**NSLPP MEETING HELD ON 07/12/2022****Attachments:**

ADDRESS/WARD: 94 Blues Point Road, McMahons Point**APPLICATION No:** DA 412/21**PROPOSAL:** Alterations and additions to terrace dwelling comprising substantial internal alterations, and excavation of new basement level and pool**PLANS REF:**

OWNER: Michael Manken & Julia Manken**APPLICANT:** Michael Manken & Julia Manken**AUTHOR:** David Hoy, Team Leader Assessments**DATE OF REPORT:** 24 November 2022**DATE LODGED:** 25 November 2021**AMENDED:** 28 October 2022**RECOMMENDATION:** Approval

Figure 13: Section AA showing height above ground level existing (indicated). Ground level relates to the existing lowest ground floor of the building

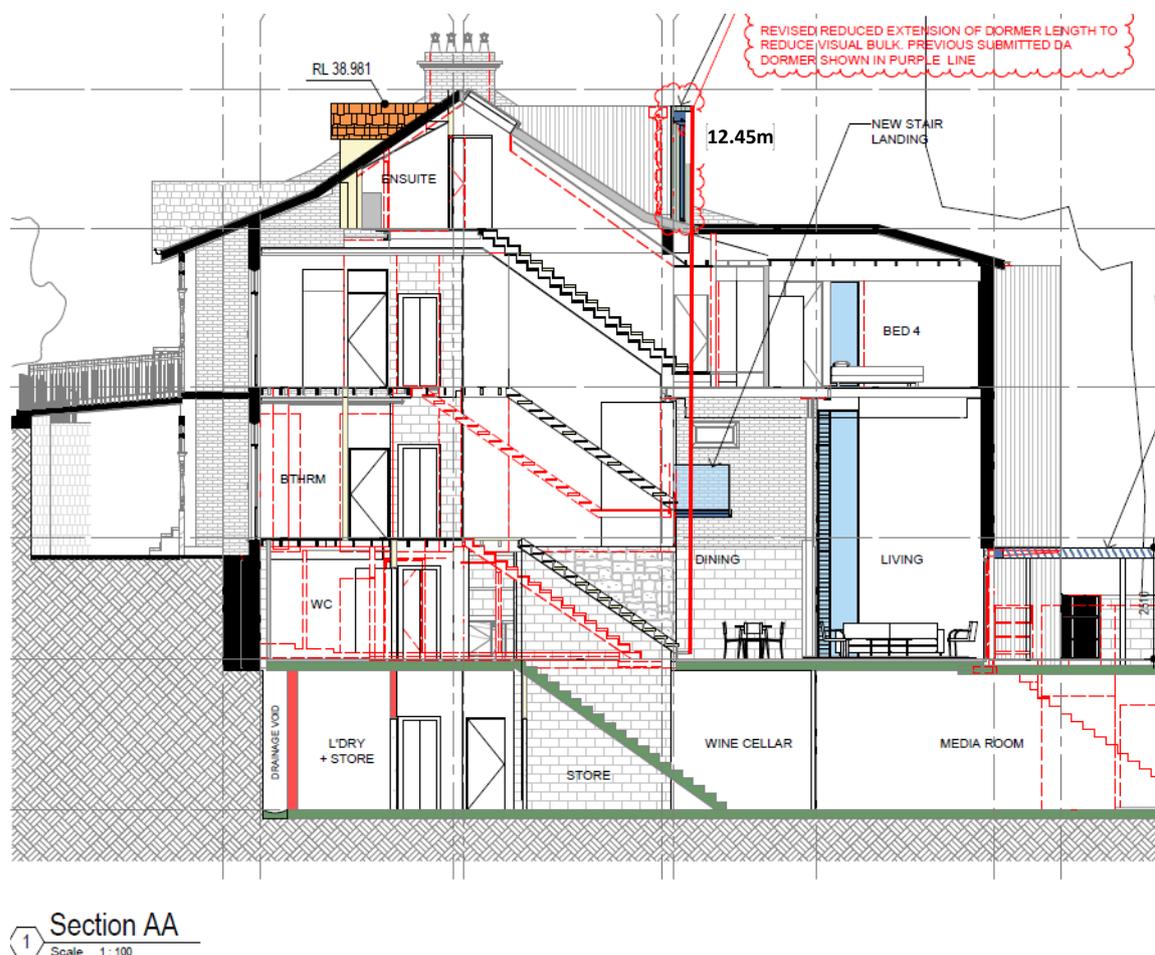
Principal Development Standards – North Sydney Local Environmental Plan 2013			
Site Area - 189.6m²	Proposed	Control	Complies
Clause 4.3 – Heights of Building	<p><i>Existing</i> 12.45m (dormer)</p> <p><i>Proposed</i> 12.45m (dormer)</p> <p>3.95m (46.5%) variation</p>	8.5	NO

The maximum building height for the site is 8.5 m pursuant to clause 4.3(2) of NSLEP 2013. The existing dormer and the proposed attic level dormer works to the dwelling would have a maximum height of 12.45m above ground level existing (as defined). The proposed amended development breaches the standard by 3.95m (46.5%) variation.

The applicant has submitted a written request pursuant to Clause 4.6 in NSLEP 2013. The written request has adequately addressed sub clause (3) and is considered to be in the public interest because it is consistent with the relevant development standard and the objectives of the zone.

Figure 14: Existing and proposed site coverage

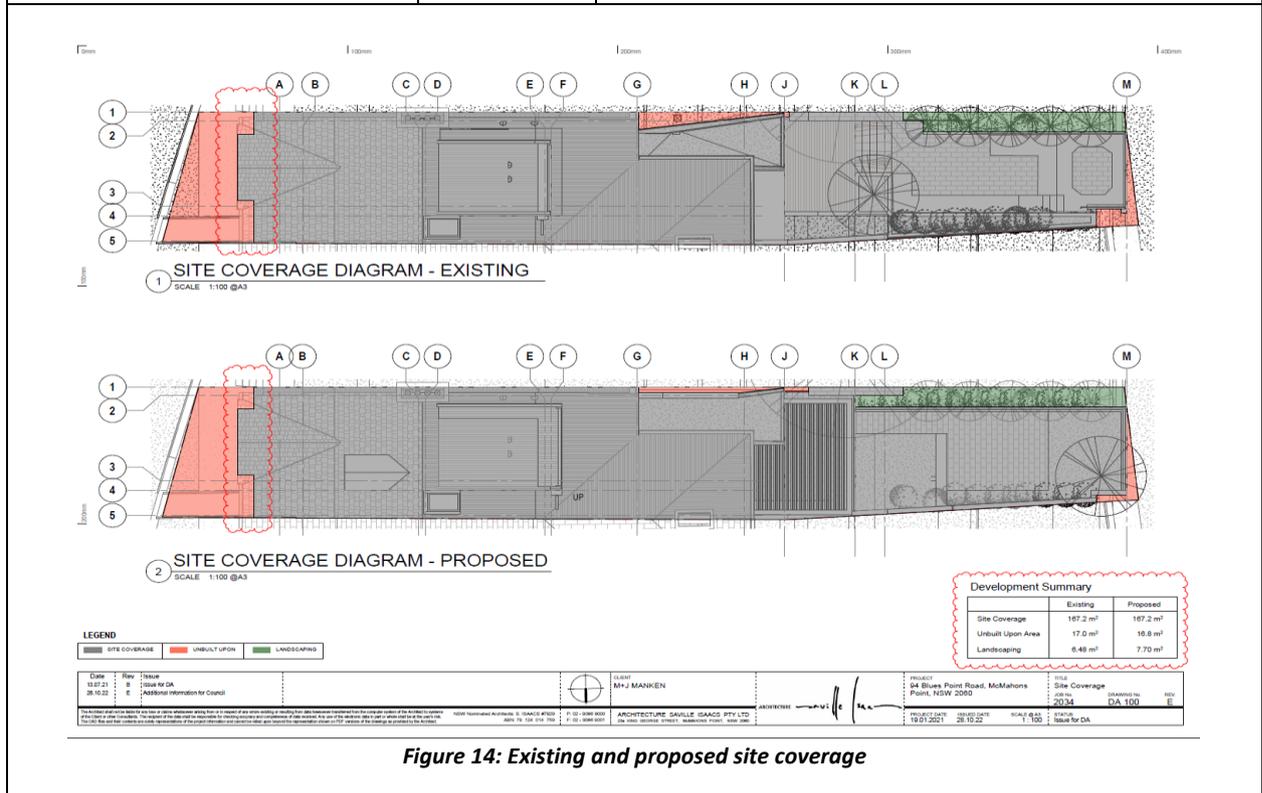
<p>1.5.4 Vehicle Access and Parking</p> <ul style="list-style-type: none"> Part B – Section 10 – Car parking Limit width of vehicle access to 2.5m 	<p>Yes</p>	<p>The proposal will provide adequate on-site car parking for the residents. The application proposed to enlarge the existing laneway garage entry by 475mm. The DCP limits the width of vehicle access to 2.5m, however the widening of the vehicle access improves manoeuvring that improves residential amenity on the Nottingham Lane. Councils' development engineer has considered the existing and proposed access and is satisfied that the proposed garage design would improve existing access.</p>																										
<p>1.5.5 Site Coverage</p> <p>Site coverage requirements of detached, attached or semi detached dwellings:</p> <table border="1" data-bbox="284 719 541 913"> <thead> <tr> <th>Lot Size (m²)</th> <th>Site Cover</th> </tr> </thead> <tbody> <tr> <td>0-229</td> <td>60%</td> </tr> <tr> <td>230-499</td> <td>50%</td> </tr> <tr> <td>500-749</td> <td>40%</td> </tr> <tr> <td>750-999</td> <td>35%</td> </tr> </tbody> </table>	Lot Size (m ²)	Site Cover	0-229	60%	230-499	50%	500-749	40%	750-999	35%	<p>No (No change)</p>	<p>Project Compliance</p> <table border="1" data-bbox="810 566 1449 725"> <thead> <tr> <th colspan="4">Table 2: Site Coverage & Landscape area</th> </tr> <tr> <th>Existing</th> <th>Proposed</th> <th>Control</th> <th>Compliance</th> </tr> </thead> <tbody> <tr> <td colspan="4">Lot: 189.6m²</td> </tr> <tr> <td>167.2m² 88.2%</td> <td>167.2m² 88.2%</td> <td>113.76m² 60% (max)</td> <td>No</td> </tr> </tbody> </table> <p>The numeric non-compliance with the site coverage controls for proposed development is indicated in the Site Coverage compliance diagram below at Figure 14. The existing and proposed site coverage are consistent due to the existing high site coverage resulting from the preceding approvals on the site. The modified site arrangements largely constitute a reconfiguration of the existing structures on site, with some improvement to the quality and standard of on slab landscaping to the garage roof terrace</p> <p>Whilst non-compliant with the site coverage control, the form and scale of the proposed development is consistent with the existing and as such would not adversely impact on the separation between development, the scale or density of development on the site. Surrounding developments are characterised by high site coverage.</p>	Table 2: Site Coverage & Landscape area				Existing	Proposed	Control	Compliance	Lot: 189.6m ²				167.2m ² 88.2%	167.2m ² 88.2%	113.76m ² 60% (max)	No

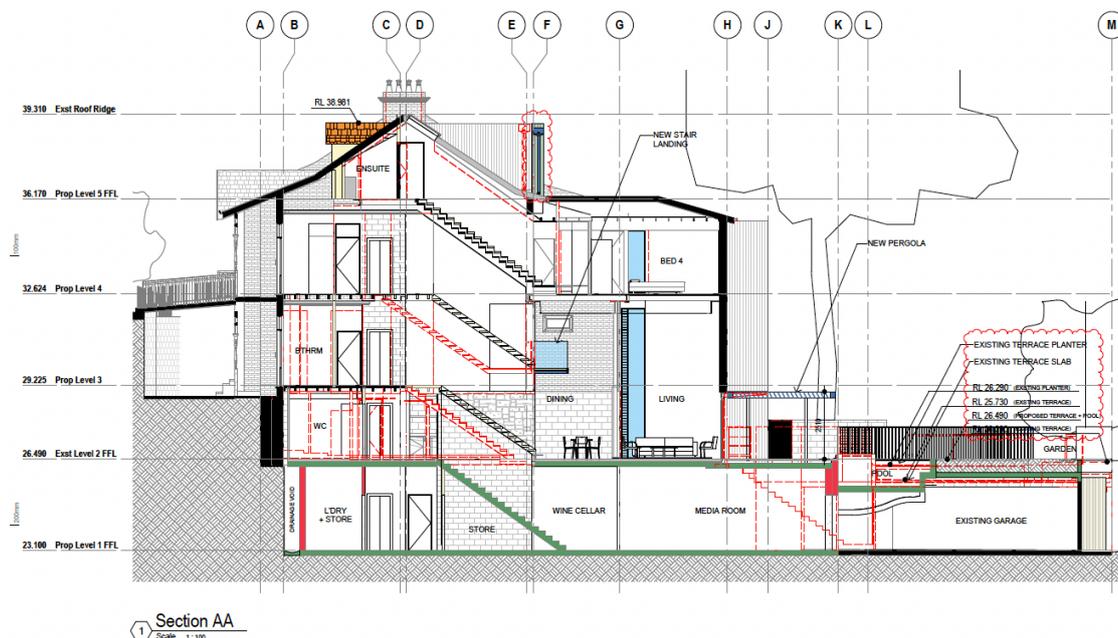
The extended dormer at the rear of the existing attic roof will be 12.45m in height at RL38.94 above the lower ground floor level at RL26.49. The small front dormer at RL38.98 is slightly higher at 12.49m above the same ground level. Whilst they will be lower in height than the highest part of the existing roof, these new and extended roof elements will also exceed the 8.5m height of buildings standard.

Figure 5.1 Demolition plan from the 2011 works. Note the rear wing alignment

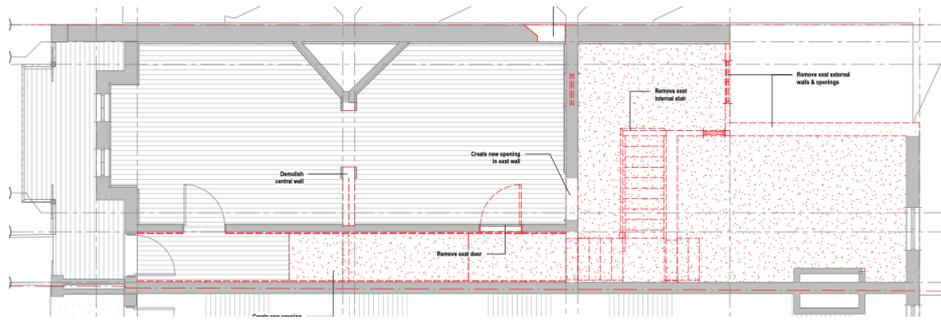
Response: The current angled wall to the side elevation is part of the 2011 works that were designed by Humphrey and Edwards Architects. It is a modern detail that in no way reflects the original arrangement of the house (see Figure 5.1). The 2011 rear extension was done in a manner that signalled the extent of the original rear wing in the rear elevation and this arrangement is maintained in the current proposals (see Figure 5.2).

The proposal to straighten the alignment of the wall is perfectly reasonable in this instance and will not impact on an original form or detail as the house has been very heavily altered at the rear.

Figure 5.3 Current house plans

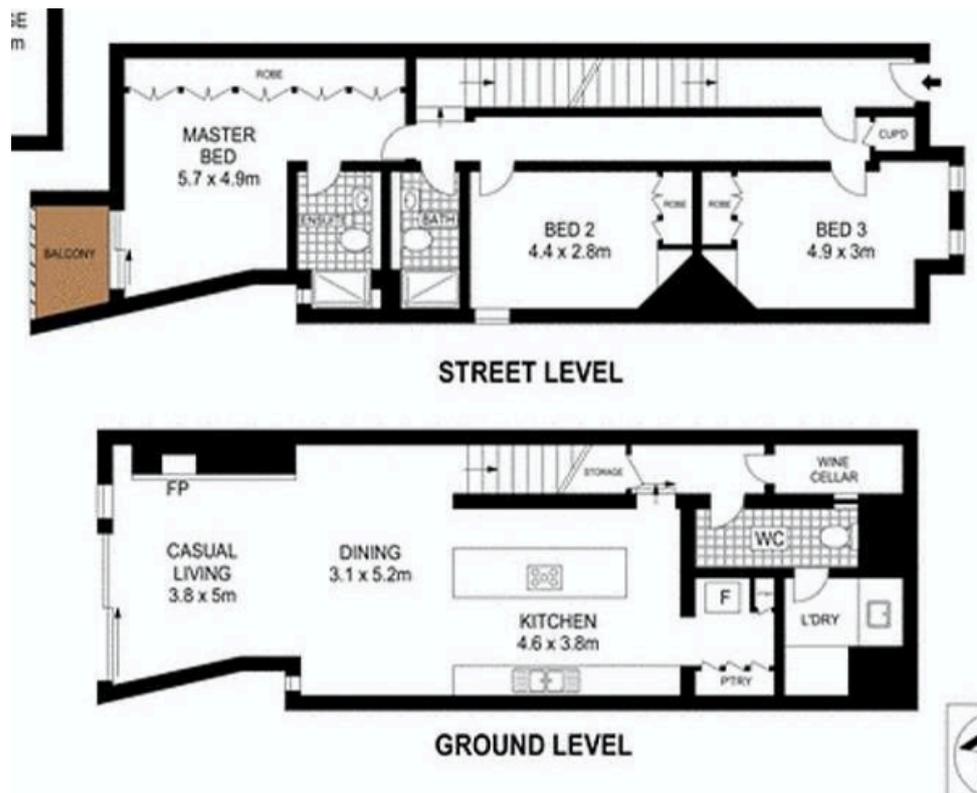
The front portion of the house has been very heavily altered with a secondary hall added and a new stair inserted into the original hall.

Figure 5.6 Views to the rear the dormer from Blues Point Road

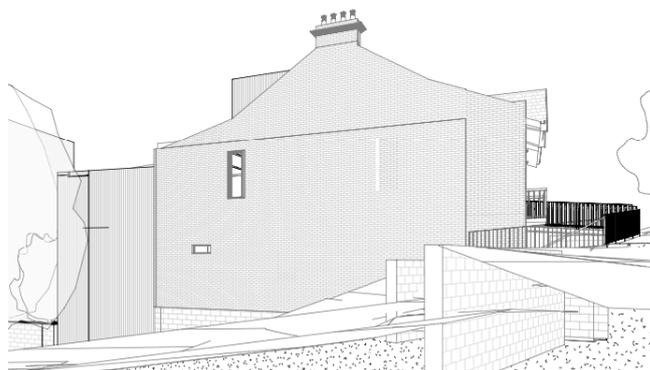
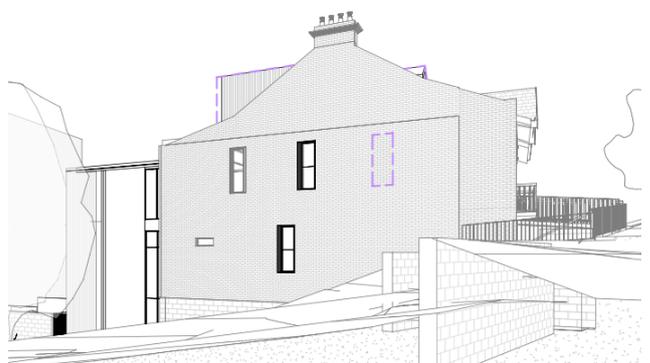
The rear dormer is extant and the proposal is to extend this to provide a reasonable level of accommodation in the upper bedroom.

The proposed dormer extension has been reduced in length with only a slight increase in the wing walls with the glazing set to the face of the wing walls. The rear roof is very large and the amended dormer is in scale with the overall scale of the roof. As can be seen from the images below, the change will be imperceptible from the street and the dormer cannot be seen from Nottingham Lane.
